SDIS1 HW Change Document

Product: SDIS1
Author: Vivian Kill-Tollnek, Emil Schuster, Tobias Cremer
Approver: CTC Advanced
Date: 28.09.2016
Version: v2.3
Status: Draft
Location: P:\SDIS1\05_SW08_Certification\TCF

1 Introduction of HW42

1.1.2.1.2 BT antenna

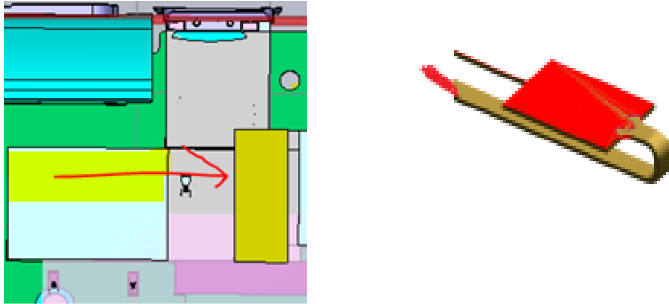
Pattern tuning + move grounding on audio shielding

Figure 1 Schematic drawing of change for voltage undershoot correction

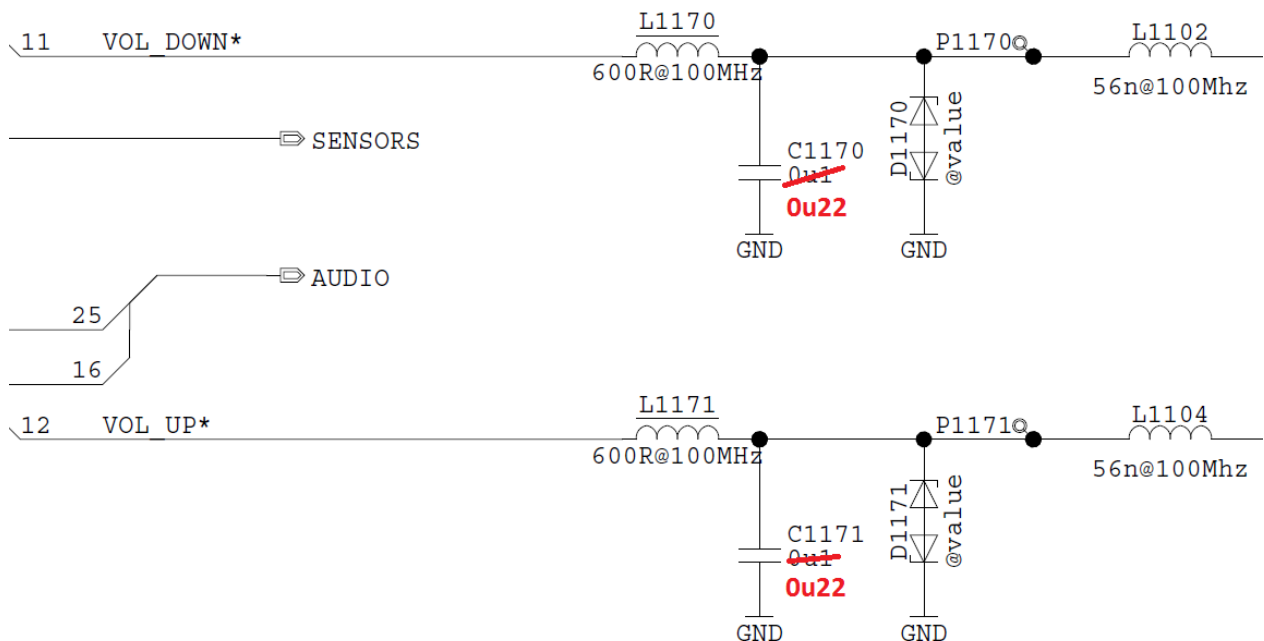
Changes: Increase value of capacitors C1170 and C1171 from 0u1 to 0u22 (1100254 Capacitor 0402 0u22 +/-10 % 16Vdc Murata GRM155R71C224KA12D)

Reason: Signal undershoot at falling edges of VOL_UP* and VOL_DOWN* exceeding absolute maximum ratings of -500mV according to NVIDIA datasheet.

Figure 4 Drawing of change

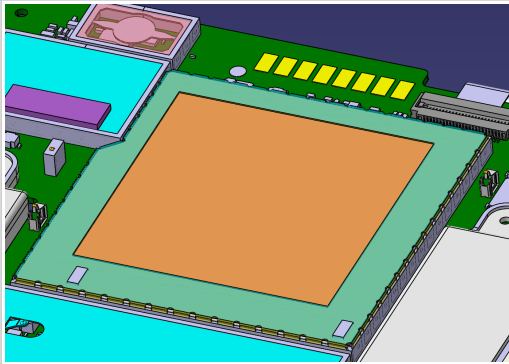
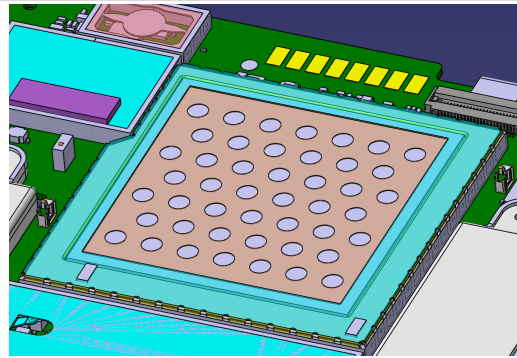
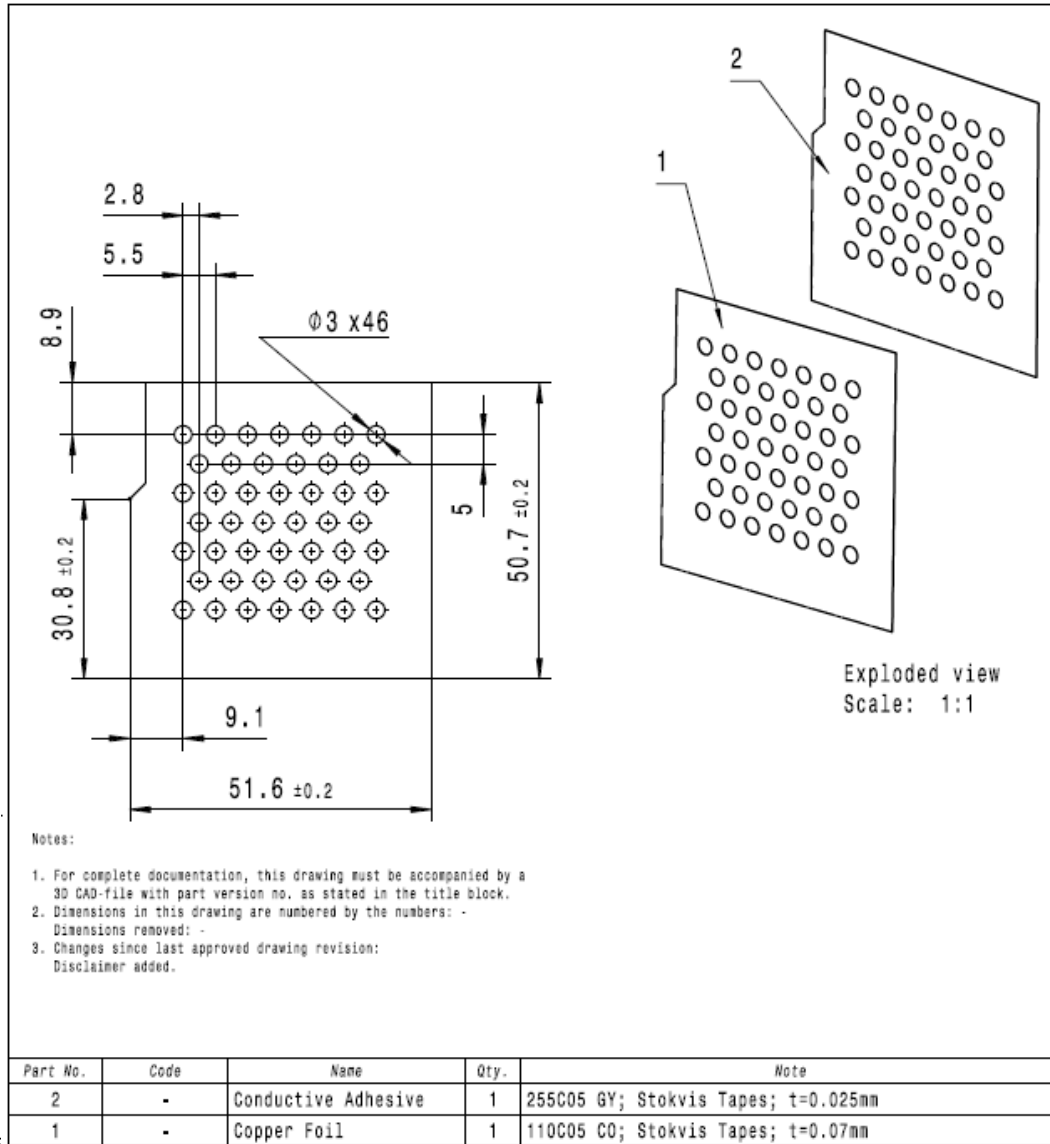
Added holes to copper foil to avoid air trapped in under foil in gluing process.

Copper foil is still attached to entire metal surface of processor with electrically conductive glue, thus holes do not affect EMI performance.

Figure 5 Image of antenna flex change, before and after

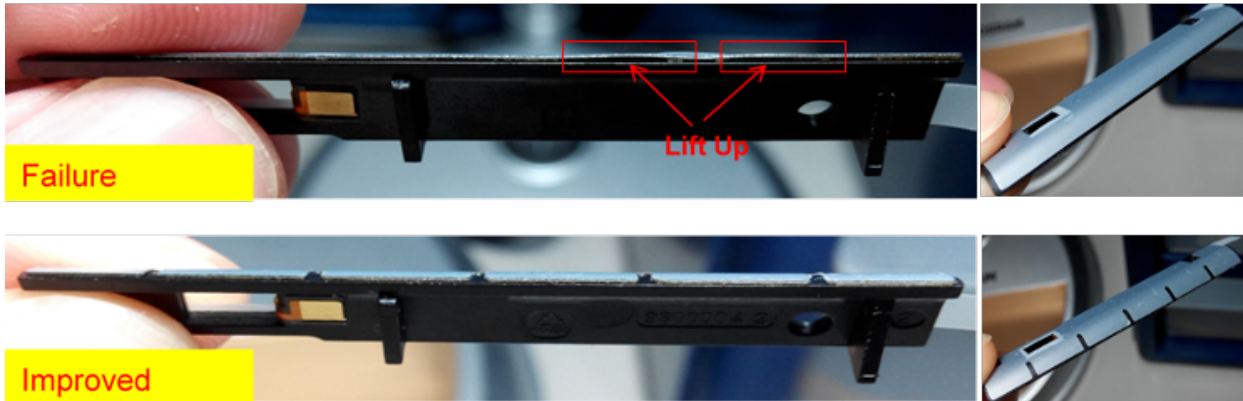
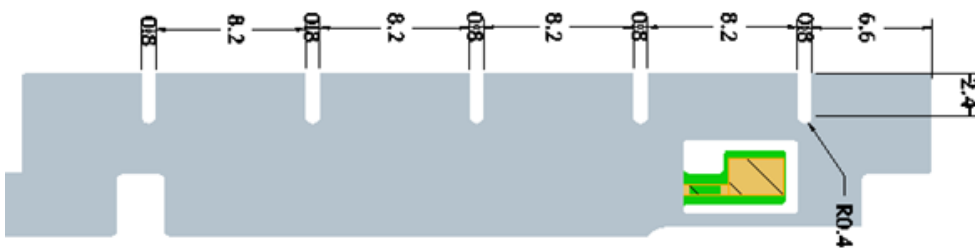
Radius of GPS antenna flex is too tight, added cutting lines to improve reliability and keep performance.

Figure 7 Schematics of RGB LED test points

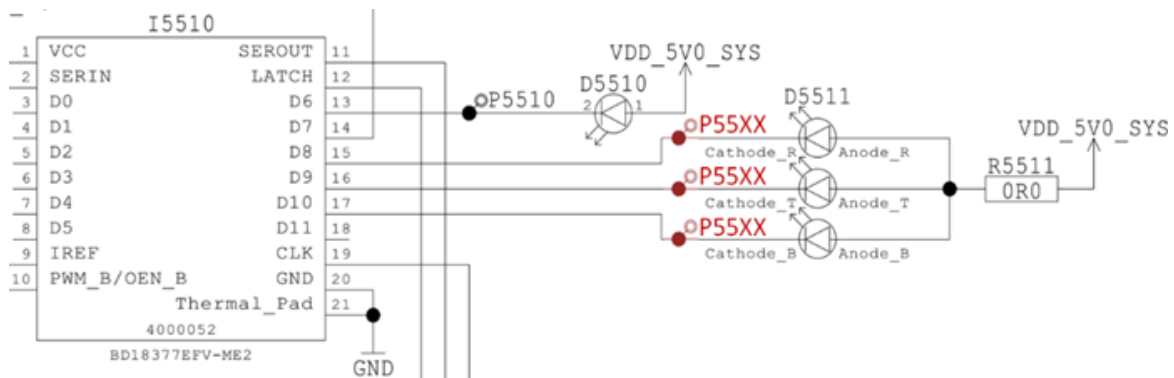
For production testing, test points on the PCB were introduced.

Figure 8 Drawing of change of geometry of PMU Shieldings

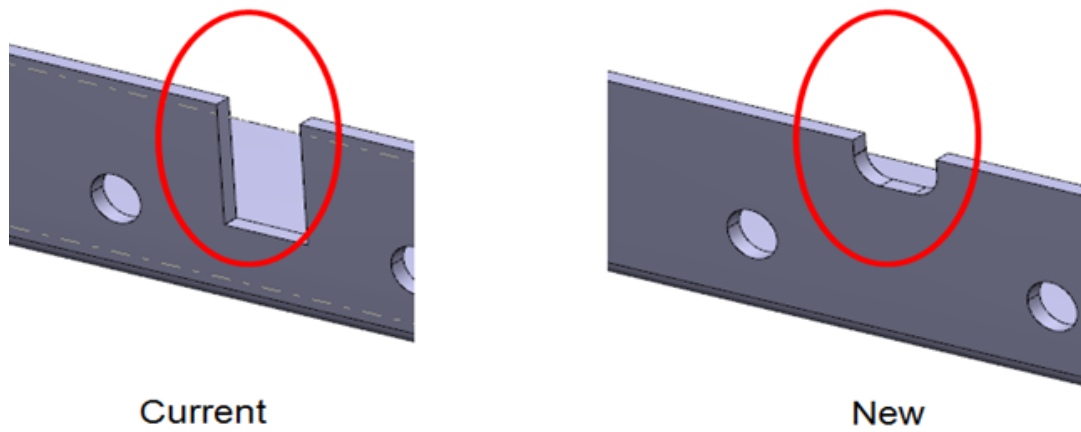
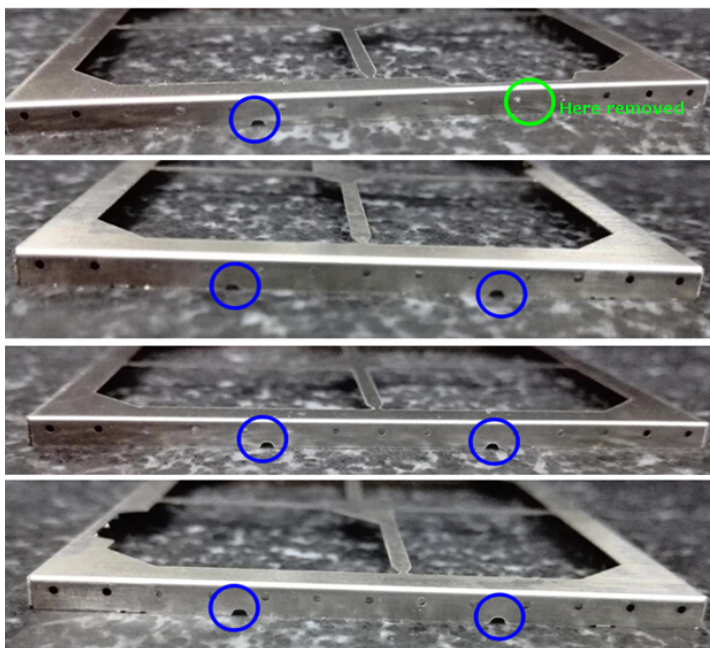
1.1.2.6 Change in PMU Shielding geometry

Figure 10 Components added for system crash prevention

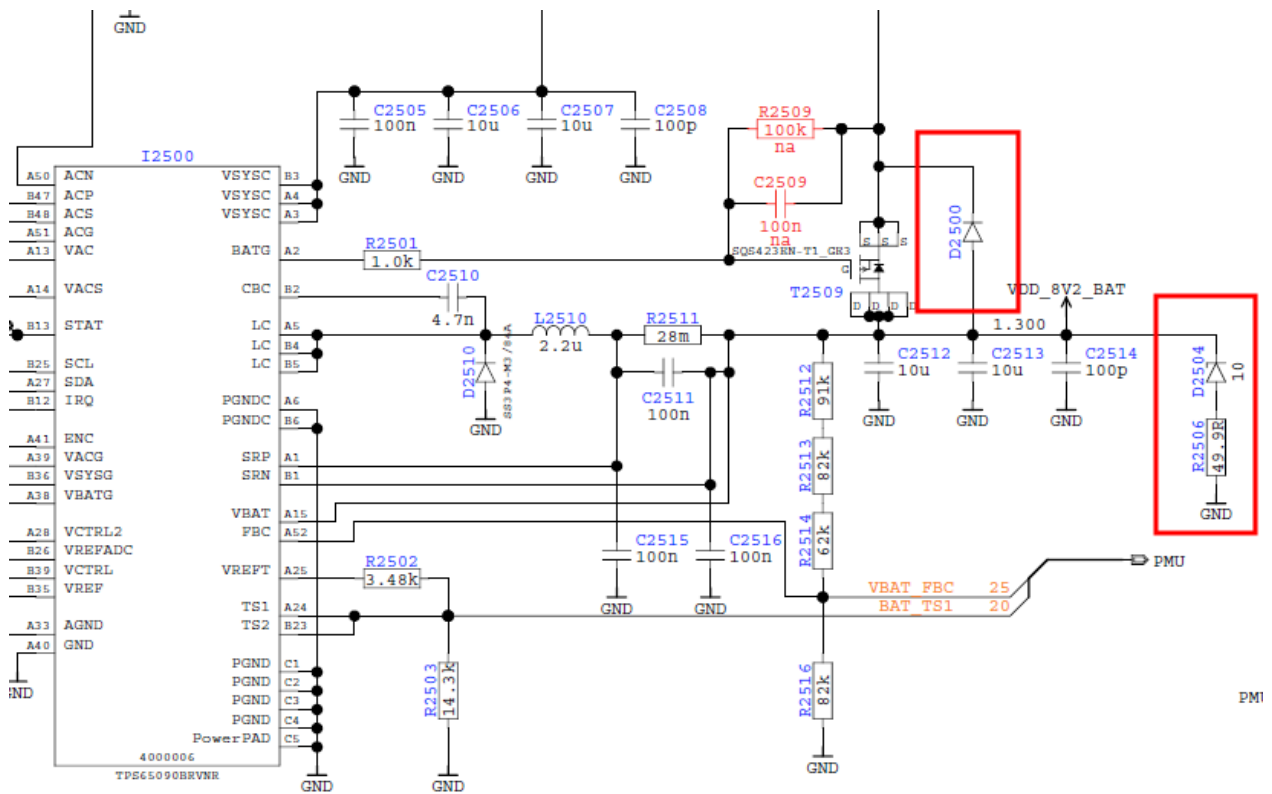
Added Schottky-diode and leakage compensation to avoid that system crashes under certain conditions.

Figure 11 Component added for RX line termination

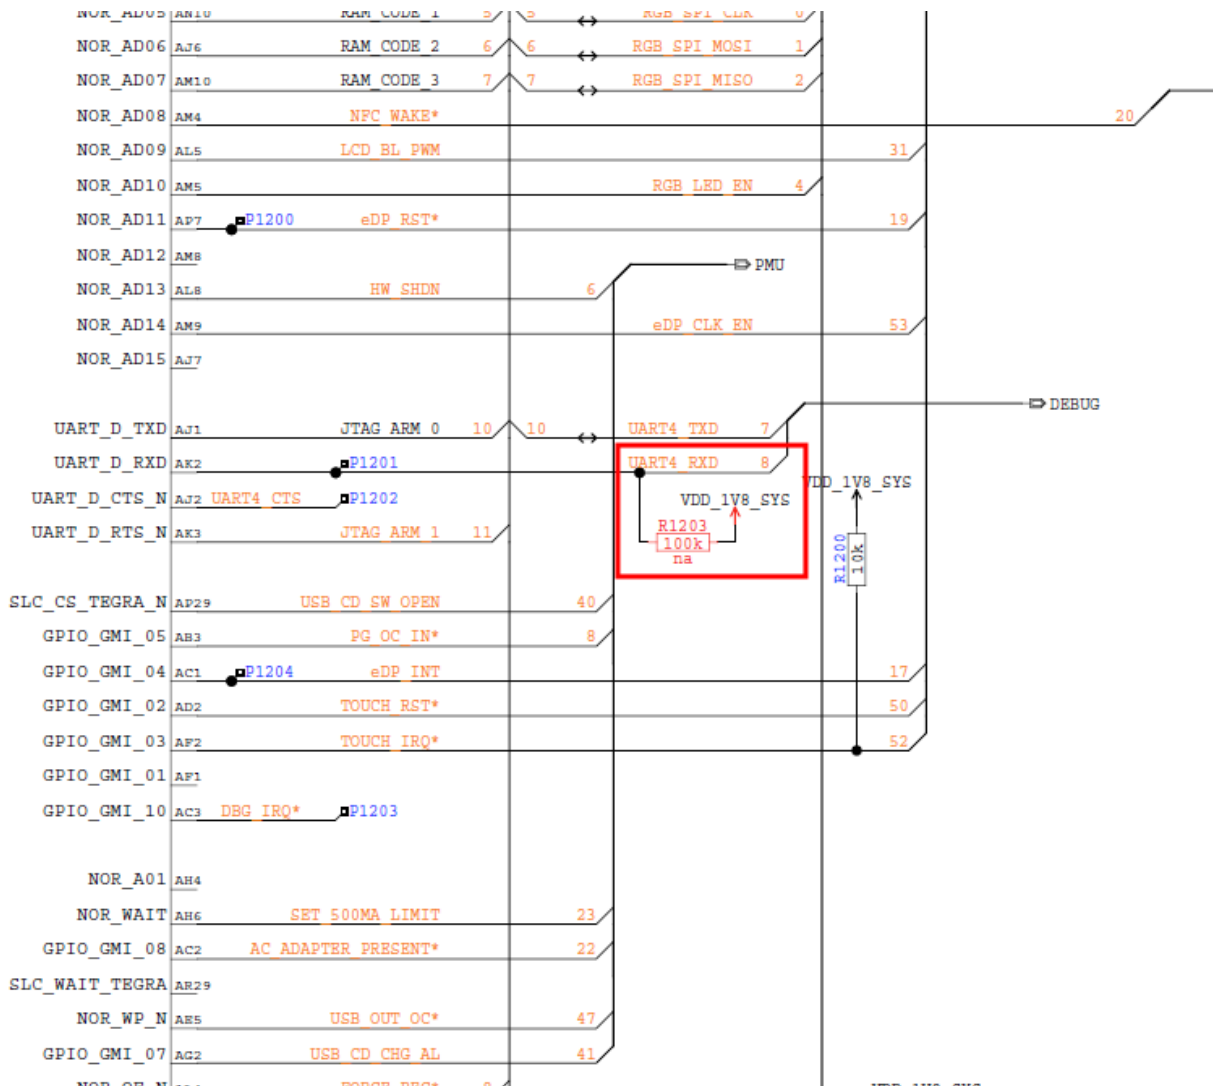
Rx (signal to VCM) line of internal debug connector is currently floating and needs to be terminated to avoid false input signals.

Figure 12 Components added for EMC correction at 750kHz

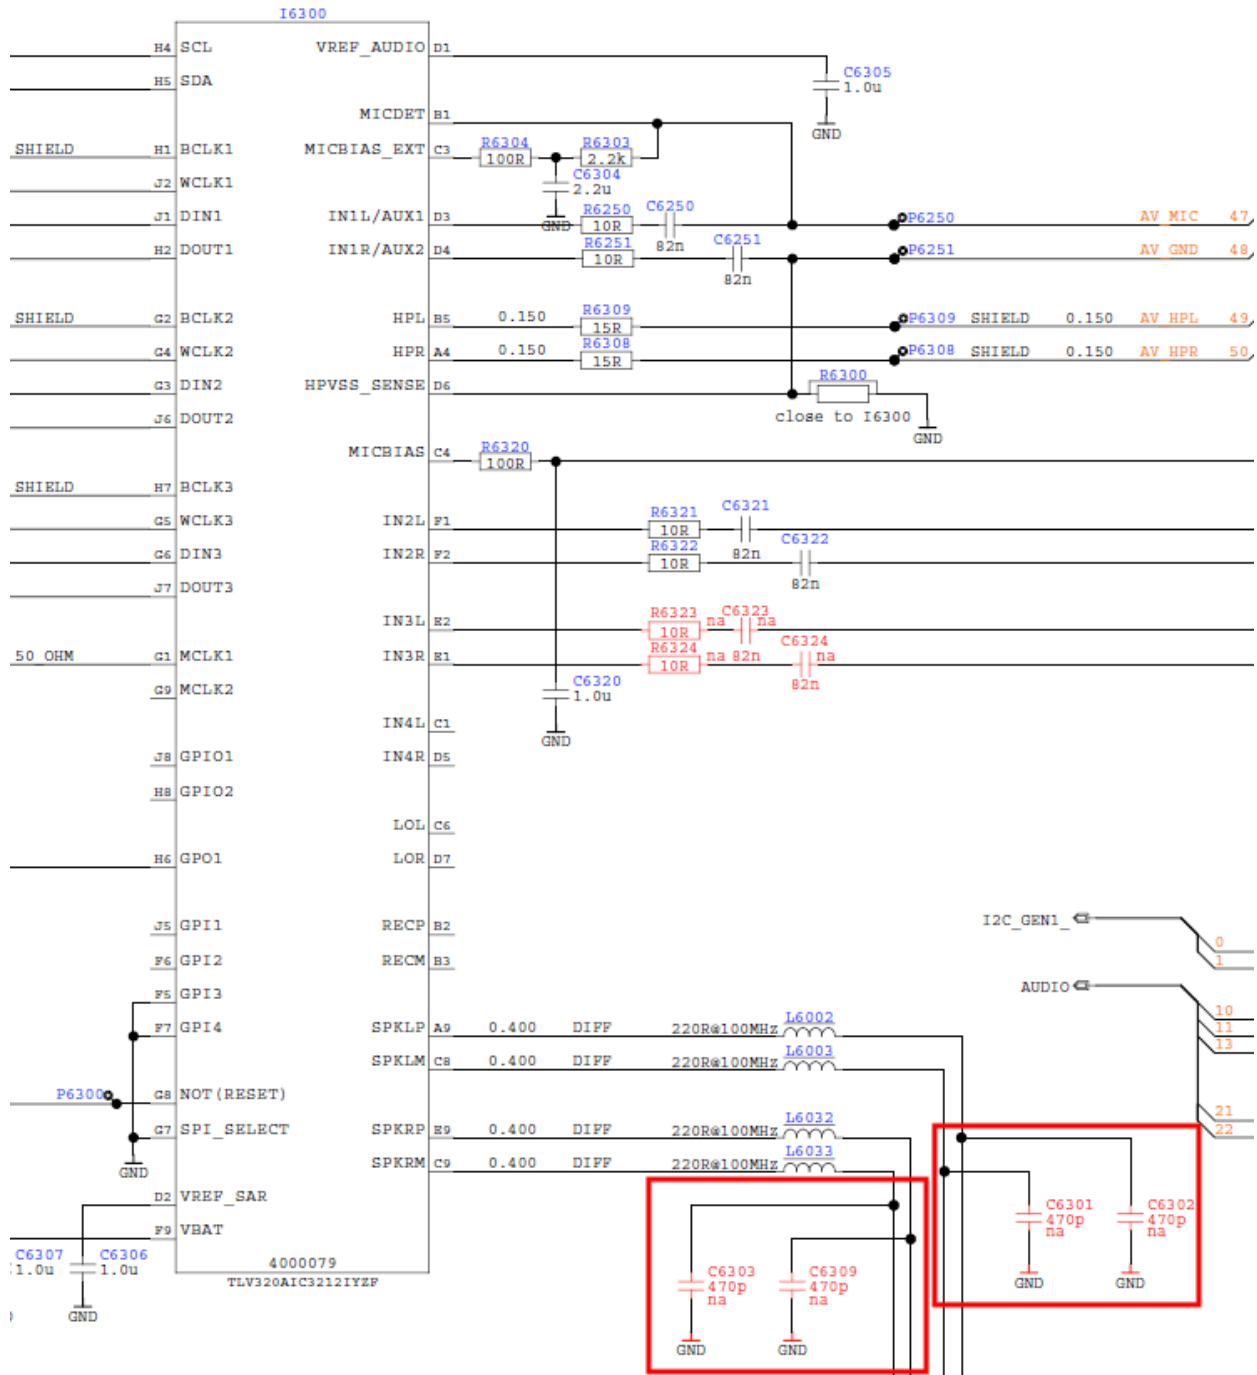
Added one capacitor to ground at each audio output line of the audio codec I6300. Capacitors to be placed after ferrites L6002, L6003, L6032, L6033 to ground. Parts to be set to not assembled.

Description of the capacitor: Capacitor 0402 470p +/- 5% 50Vdc AEC-Q200

Figure 14 Schematics after change

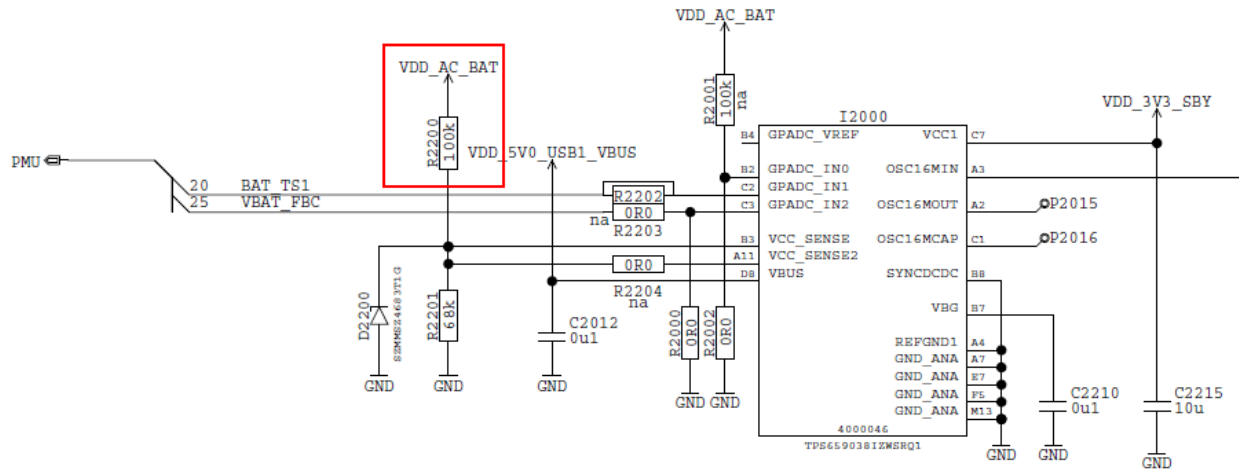
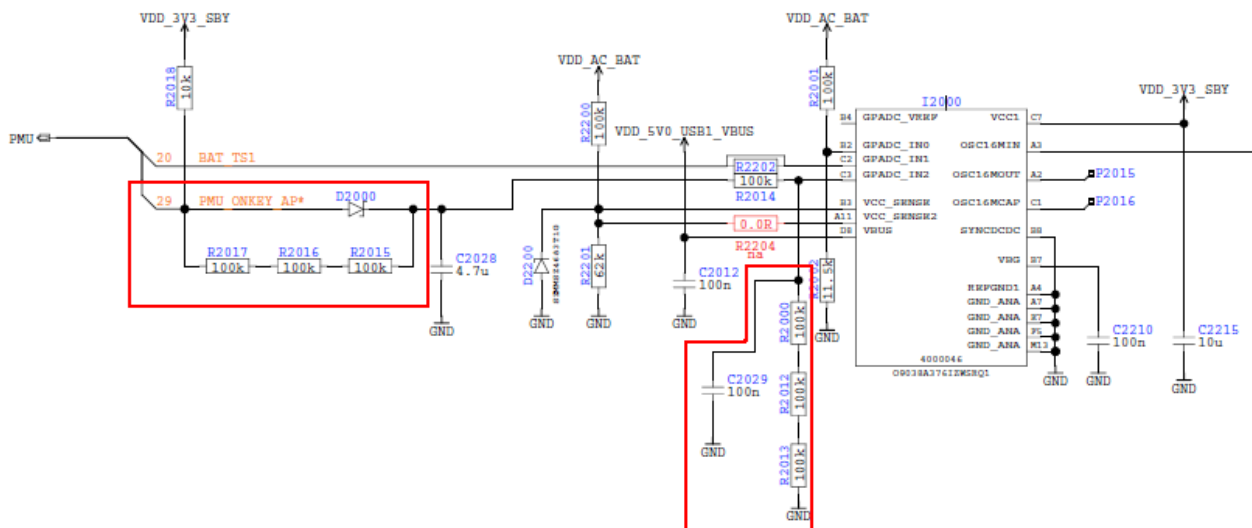
Debouncing circuit to improve user experience by decreasing response time of power button press while device is being started in charger/hidden mode.

Figure 15 Schematic drawing of component added for USB-charging stabilisation

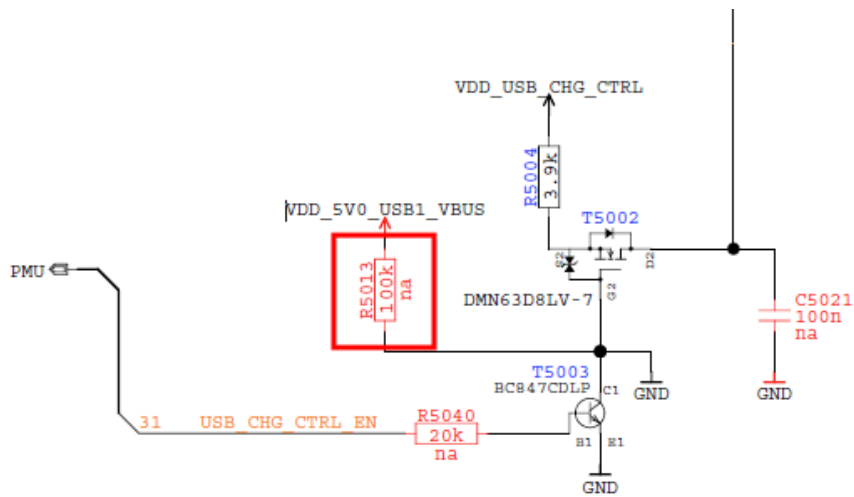
Reason: Corrects a potential malfunction in USB charging mode, to allow for reliable charging with 500mA

Technical solution: One additional ground connection (via) on engine PCB.
